Amendment Report

WELLINGTON NORTH SOLAR PLANT

AUGUST 2019

The Wellington North Solar Plant proposal remains generally as detailed in Section 4 of the EIS (NGH Environmental, 2018). However, two changes have been made since the public exhibition of the EIS, regarding the transmission line route and site access. These changes have been made in response to submissions and further detailed design.

Figure 2-1 Updated proposal layout.

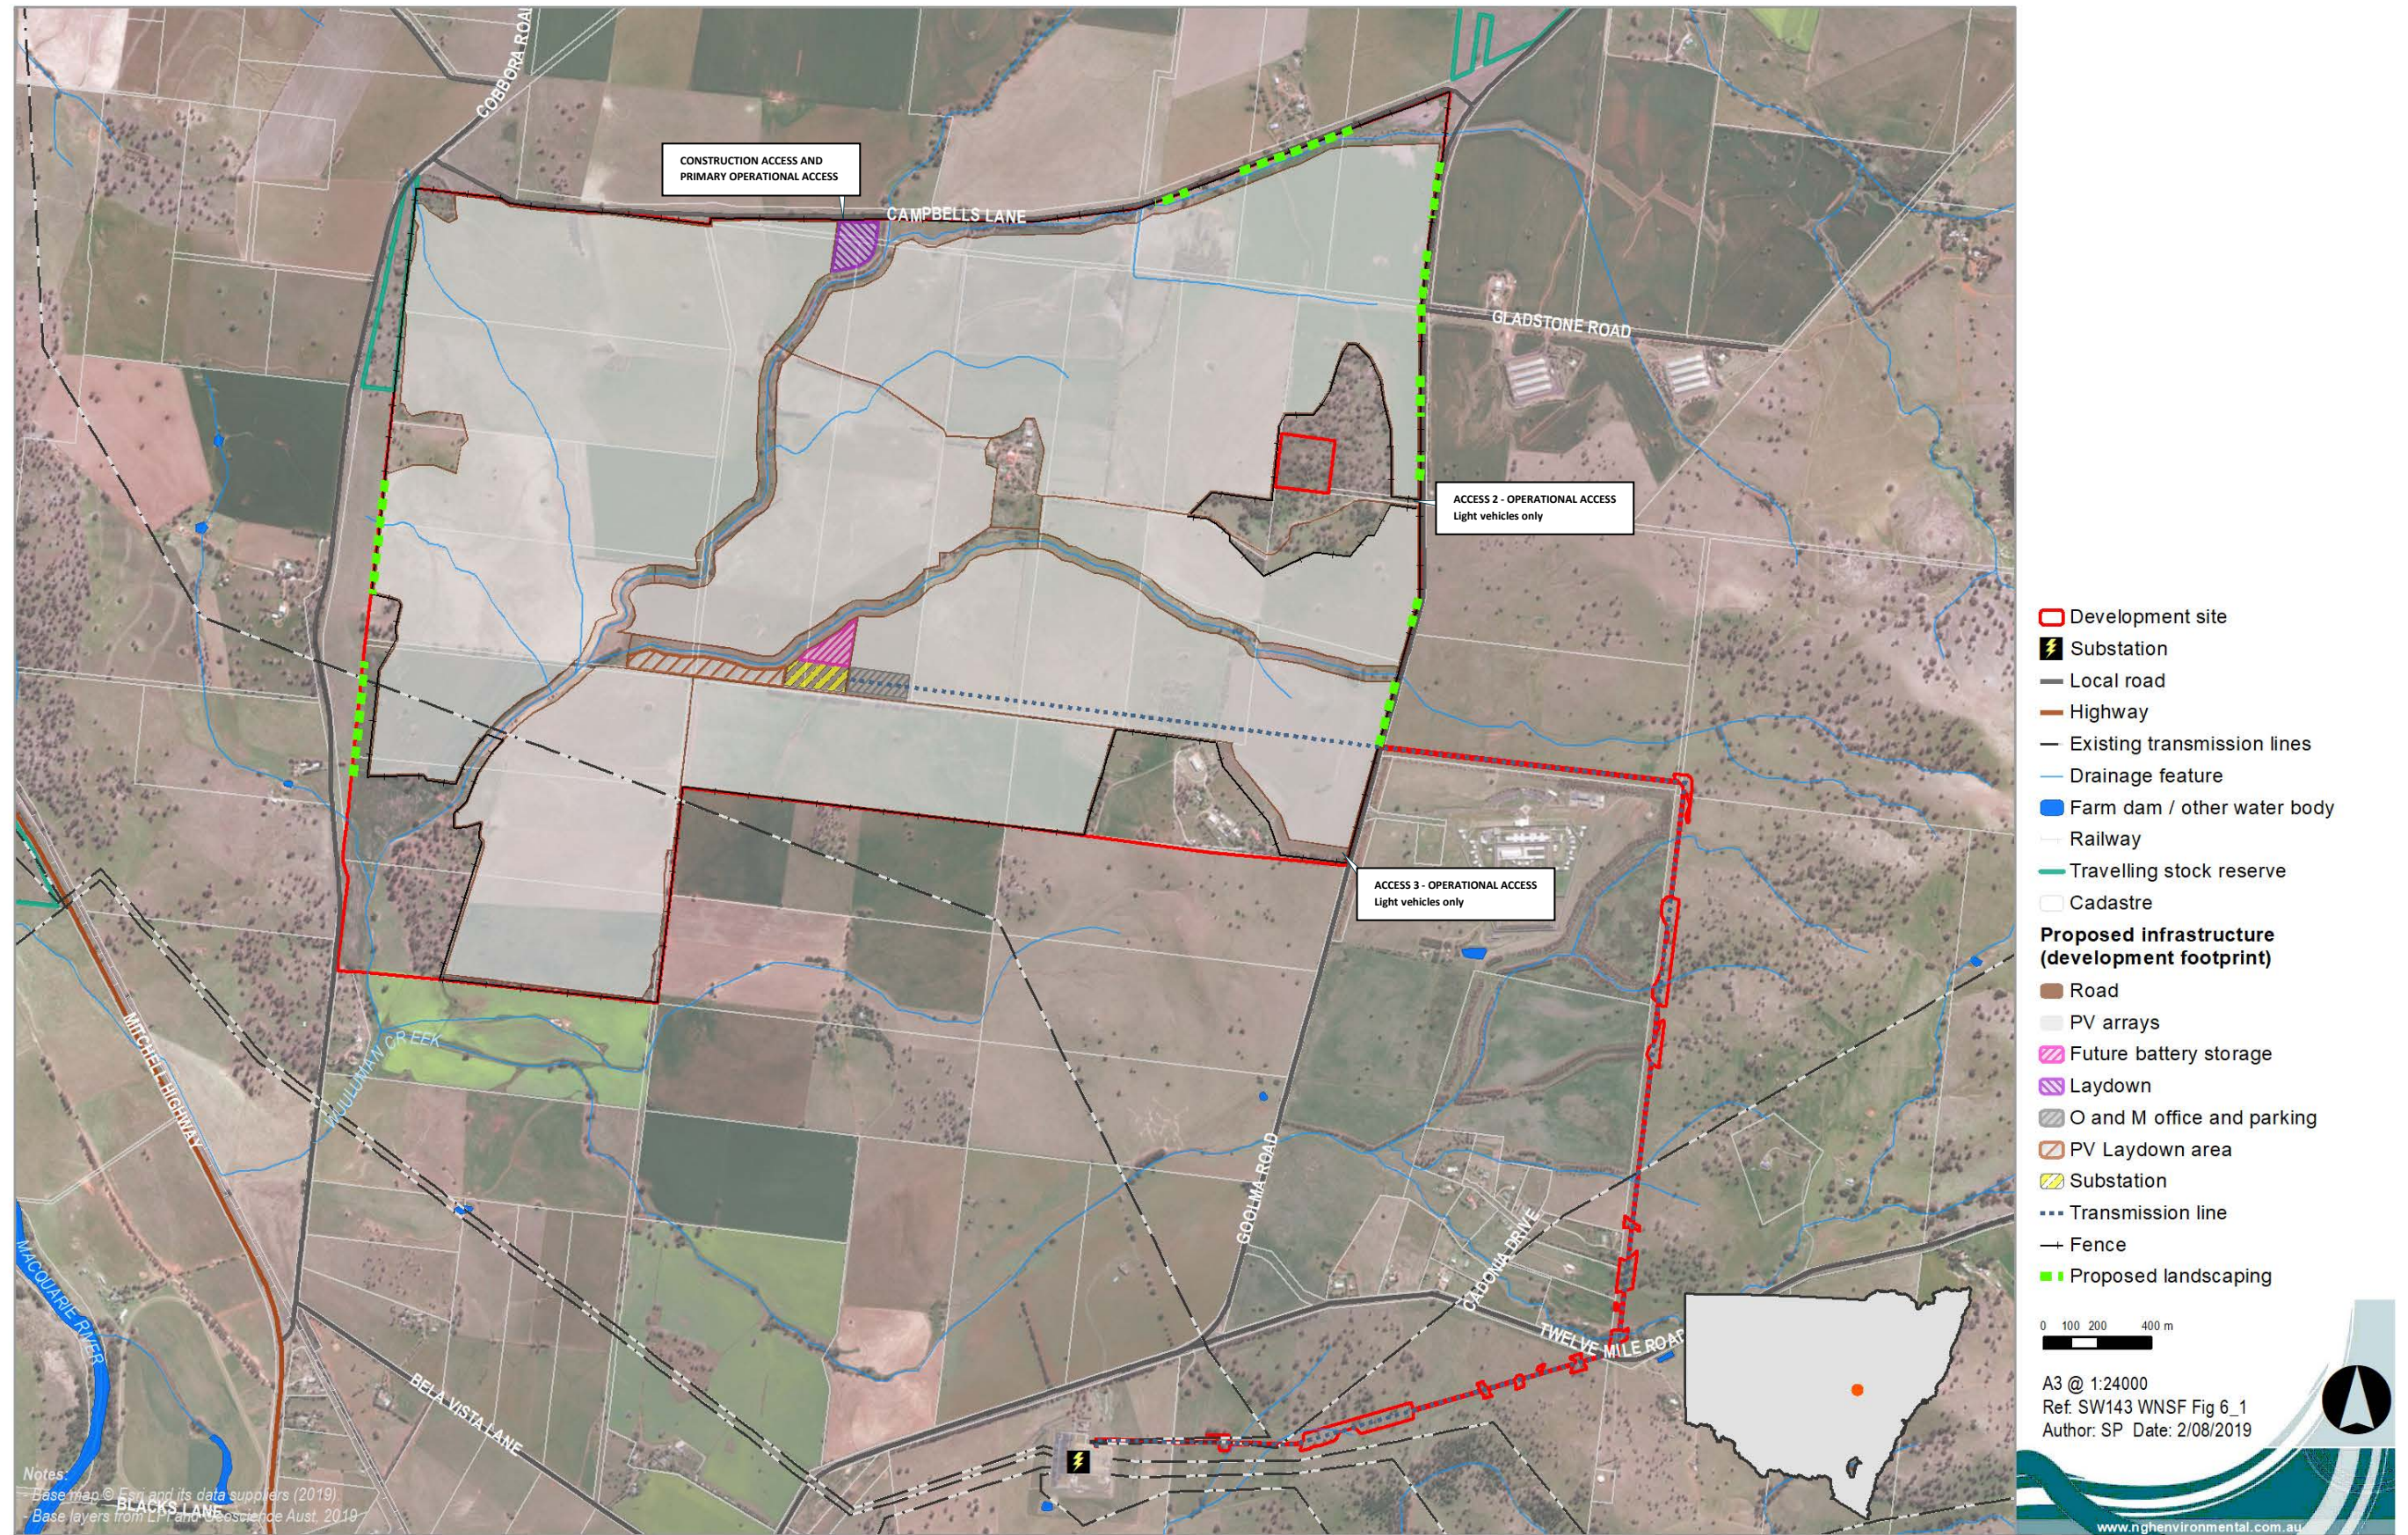
The proposed new eastern transmission line option that would connect the solar plant to the existing Wellington Substation would be a 132kV or 330kV overhead transmission line. From the solar plant site, the transmission line would cross Goolma Road, approximately 400m north of the Soil Conservation Service site access. It would continue east for approximately 1.1km to the eastern side of the Wellington Correctional Centre, before heading south to Twelve Mile Road for approximately 2km. It would cross Twelve Mile Road and enter the Wellington Substation from the east (refer to Figure 2-1). The transmission line would occur in the following lots and Deposited Plans (DPs):

In response to Roads and Maritime Services submission for the EIS, AGL has now committed, as part of this proposed amendment, that all construction site access would be via Campbells Lane as the use of Campbells Lane for all construction access including all heavy vehicle access has been sufficiently addressed in the *Traffic Impact Assessment* (GHD, 2018) (Appendix K of the EIS).

- **Access Point 1:** The primary access point would be via Campbells Lane along the northern boundary of the site. This access would be used for light and heavy vehicles.
- **Access Point 2:** The existing driveway off Goolma Road that leads to the Soil Conservation Service facilities. The access point may continue to be utilised by Soil Conservation Service staff in addition to light vehicle access to the solar plant. By exception only, the access point may be required for some heavy vehicle movements, such as the delivery high voltage transformers.
- **Access Point 3:** The existing driveway off Goolma Road that leads to the residential dwelling on the property. This access point would be utilised by light vehicles only.

Figure 2-2 Updated constraints map

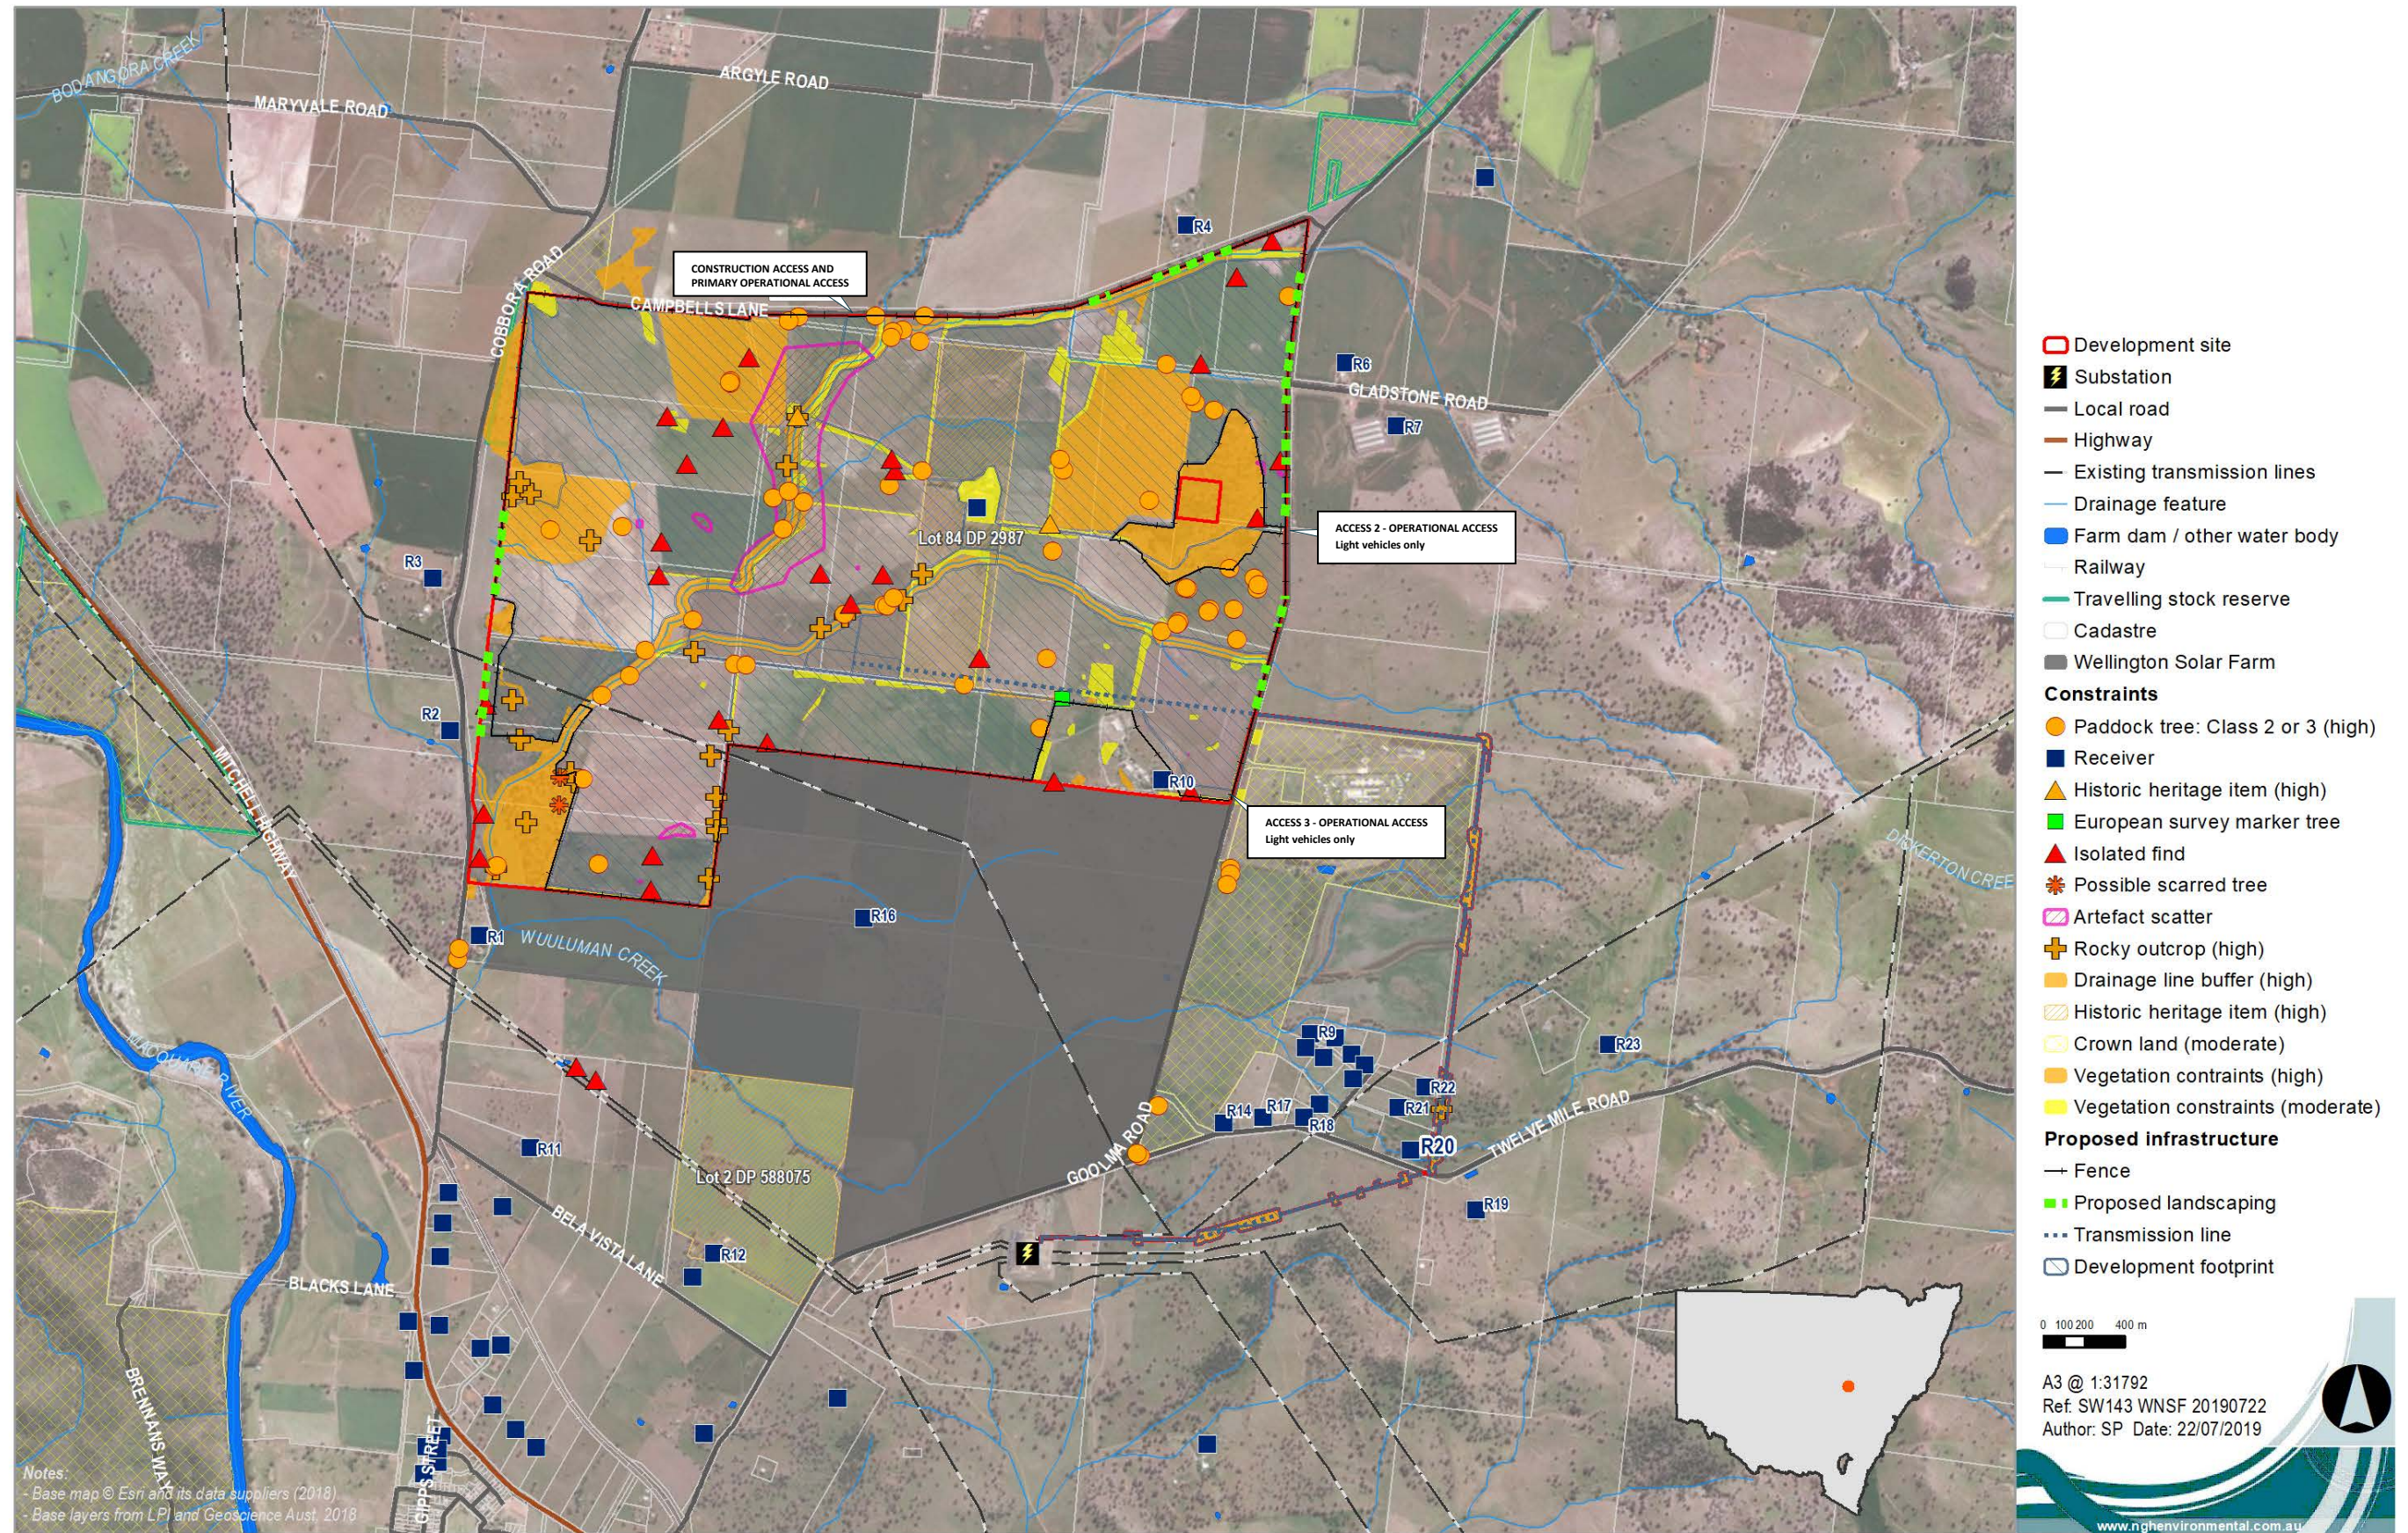
easement. This was undertaken to identify the most appropriate route within the study area. The area of vegetation removed within the easement would be approximately 9.43ha (as determined in the revised BDAR-v2.3, NGH 2019b). The line would involve three different land owners. Table 2-1 compares the proposed new eastern transmission line option to the two transmission line options presented within the EIS. The new eastern transmission line is considered to be substantially the same as the transmission line options presented within the EIS as the impacts are kept to a minimum.

EIS Eastern transmission line option (underground)	EIS Western transmission line option (overhead)	New Eastern Transmission line, now proposed
Maximum easement footprint (hectares)	7	31	30-31
Number of non-involved landowners directly adjacent to the easement	2	5	8 (inclusive of 3 landowners that would be separated from the easement by Twelve Mile Road, refer to Figure 2-2)
